RENESAS TECHNICAL UPDATE

Classification of Production	MPU&MCU		No	TN-SH7-494A/E	Rev	1
THEME	SH7760 type number change due to logical modification.		Classification of Information	1. Spec change 2. Supplement of Documents 3. Limitation of Use ④ Change of Mask 5. Change of Production Line		
PRODUCT NAME	HD6417760BP200D HD6417760BP200DV	Lot No.	Reference Documents	SH7760 hardware manual Rev 1.0 (ADE-602-291)	Effective Date	
		All			Eternity

The mask of SH7760(HD6417760) is changed due to logical modifications described below. Please see the following new type number.

Figure 1. Modification for Figure 25.4 in Hardware Manual Rev 1.0

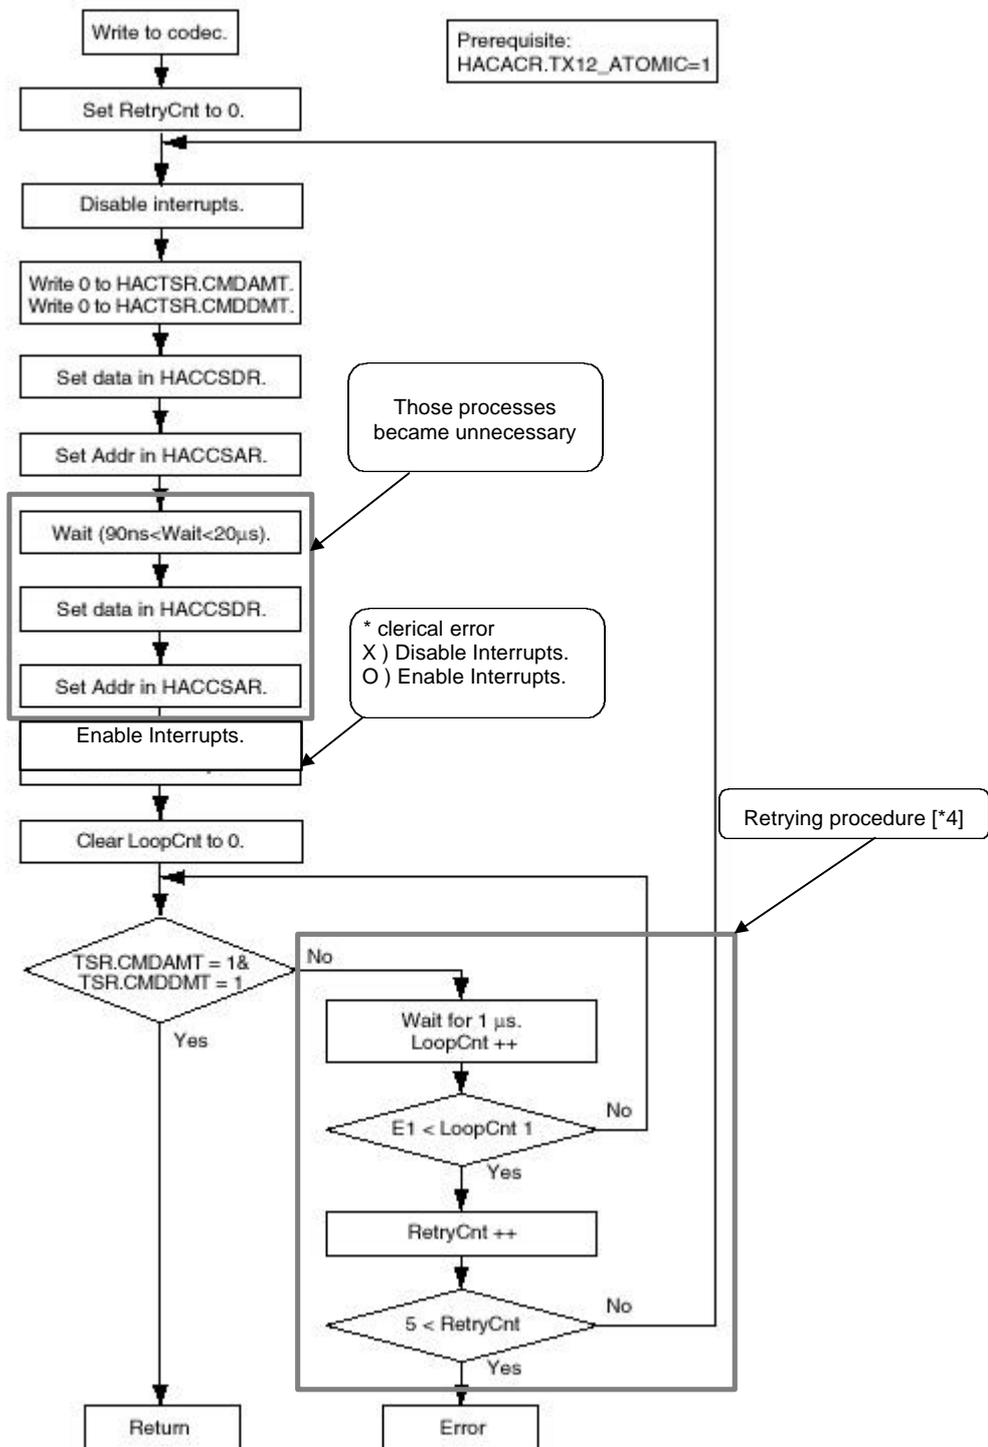
+ About Section 25.5.5 (1) "Writing a codec register address to HACCSAR" :

Write a codec register address to HACCSAR twice with an interval of 100ns(*3)

((*3):Waiting time can be set from 90nsec to 20µsec.)

HD6417760BP200AD/ADV : There is no need to apply this restriction. Please see Figure 1 and 2.

(*4) : Some CODEC devices may not complete accessing CODEC register within 1 slot time.
In this case, please execute this retrying procedure.
